# UNITED STATES PATENT AND TRADEMARK OFFICE

APPLICATION NO.	FILING DATE	FIRST NAMED INVENTOR	ATTORNEY DOCKET NO.	CONFIRMATION NO.
10/562,581	12/28/2005	Susumu Okazaki	36856.1389	7909

<b>Office Action Summary</b>	<b>Application No.</b> 10/562,581	<b>Applicant(s)</b> OKAZAKI ET AL.	
	<b>Examiner</b> Derek J. Rosenau	<b>Art Unit</b> 2834

## DETAILED ACTION

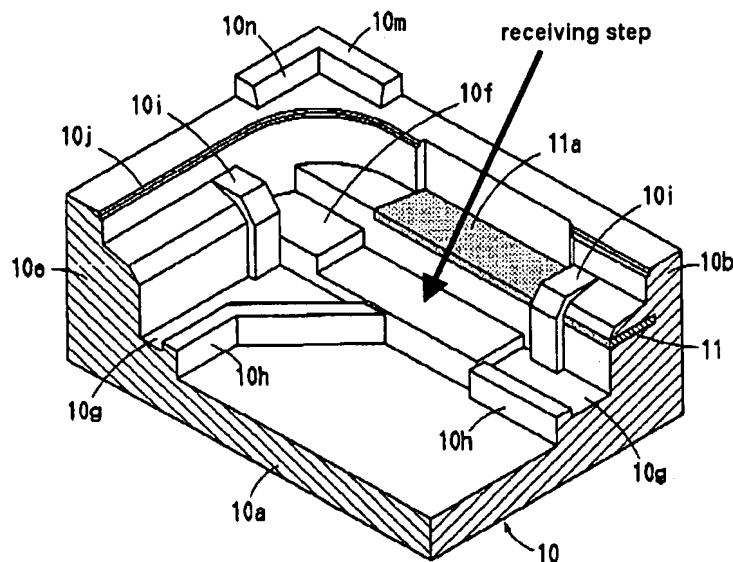
9. With respect to claim 13 Nakamura et al. discloses a piezoelectric electroacoustic transducer according to claim 7, wherein the casing includes a receiving step (see figure below, figure 8 from Nakamura et al.) having a height lower than the supporting portion and a predetermined space between the receiving step and the bottom surface of the diaphragm (Fig 8).
